SUPPLEMENTARY STAFF REPORT 06-14-2023 MEETING PREPARED BY: G. LANDSBERG
APPLICATION NUMBER: 23-8325 (TABLED AT 5-10-2023 MEETING, PENDING REVISIONS)
ADDRESS: 2998 IROQUOIS
HISTORIC DISTRICT: INDIAN VILLAGE
APPLICANT/OWNER: PAT & LANA MURPHY/MURPHY FAMILY TRUST
ARCHITECT: ROBERT G. CLARKE/CBI DESIGN PROFESSIONALS
DATE OF PROVISIONALLY COMPLETE APPLICATION: 04-11-2023, revisions 06-02-2023
DATE OF STAFF SITE VISITS: 04-19-2023, 04-20-2023, 05-04-2023, 05-05-2023, 06-02-2023

SCOPE: ERECT HOUSE AND GARAGE (REVISIONS TO APPLICATION #23-8325, TABLED 05-10-2023)

New landscape plan. Note prominence of preserved elm and robust foundation plantings. From revised materials.

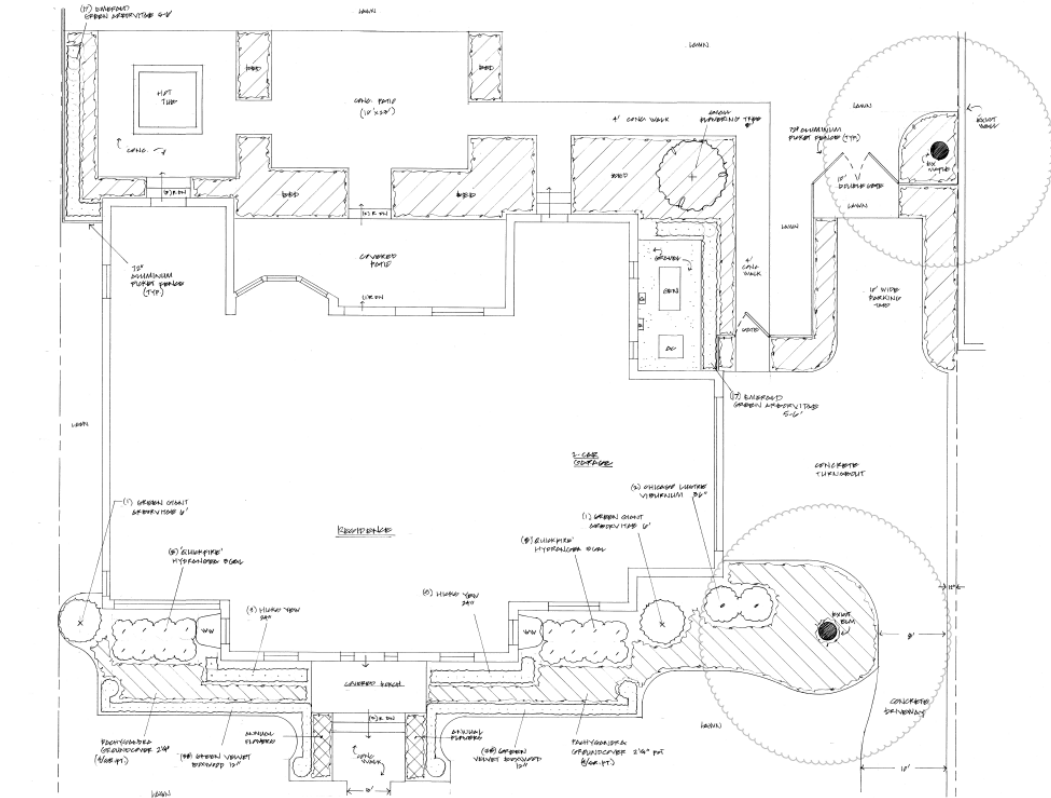
- Visibility of the three-car garage, color choices
- **Landscape plan.** A formal landscape design has now been submitted, which includes foundation plantings and a wide variety of ornamental specimens at all sides of the house. The elm tree, instead of being removed, has now been preserved and established as an anchoring element of a planting bed that

sweeps southward towards the relocated driveway. The façade now recedes slightly from the setback line. The driveway itself has been straightened and the extra path has been removed.

New garage proposed for rear of lot, side and front elevations. From revised materials.

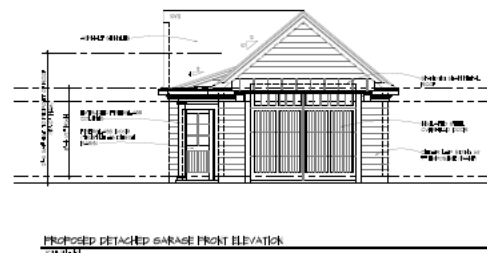
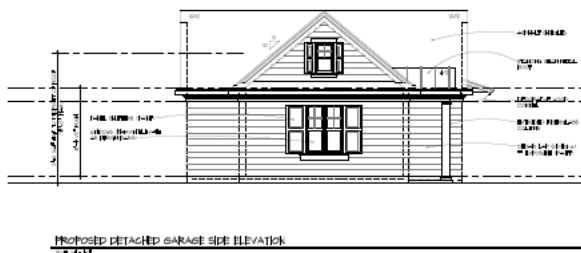
- **Garage.** The attached garage has been reduced from three doors to two doors, which are now proposed in a darker color. An additional small detached garage, constructed of cedar lap siding and sharing the vocabulary of the main house, is proposed for the rear of the lot. The net effect of these changes reduces the visual impact of the attached garage by incorporating an accessory building appropriate to neighborhood precedent.
